**IREDELL COUNTY HEALTH DEPARTMENT**
**ENVIRONMENTAL HEALTH DIVISION**
**Application For Improvement Permit**
**Site Plan Form**

MILLS FOREST LOT 3 II

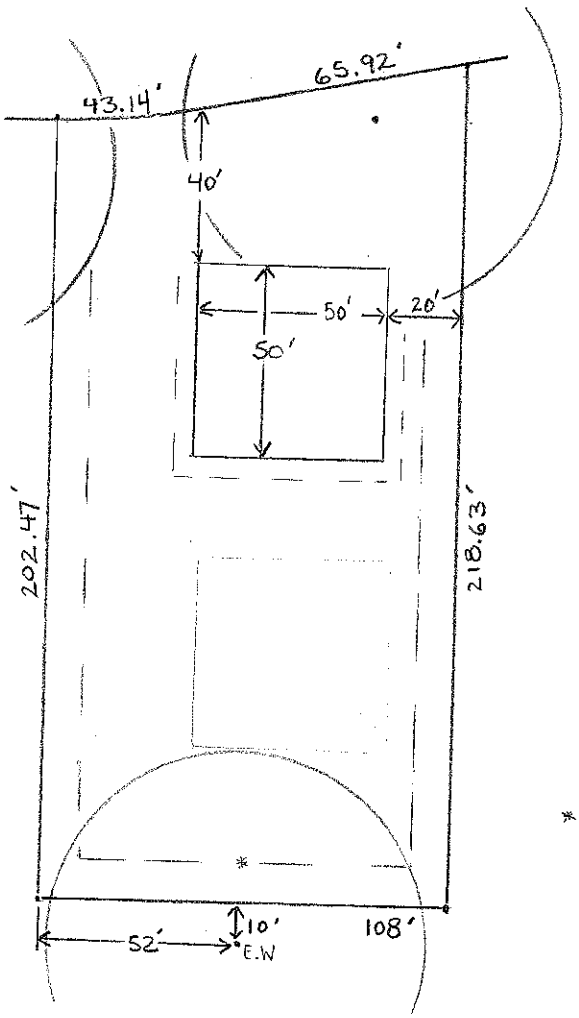
THIS LOT WILL ACCOMODATE LPP ORIGINAL AND REPAIR SYSTEMS. THE DEVELOPER I.P. WILL BE ISSUED FOR THIS. THE LOT MAY BE REEVALUATED AFTER BEING SURVEYED AND UNDER-BRUSHED.

* AN ALTERNATE LAYOUT WOULD BE TO PLACE THE WELL AT THE VERY REAR AND CENTER, MOVE THE HOUSE BACK TO ABOUT 60' OFF REAR PL AND PUMP TO THE FRONT. THE WELL ON LOT 2 COULD BE MOVED WESTWARD (CLOSER TO LOT 1) TO REDUCE THE SETBACK RADIUS ON LOT 3. THIS LAYOUT MAY POSSIBLY ALLOW FOR A CONVENTIONAL ORIGINAL SYSTEM AND LPP REPAIR.
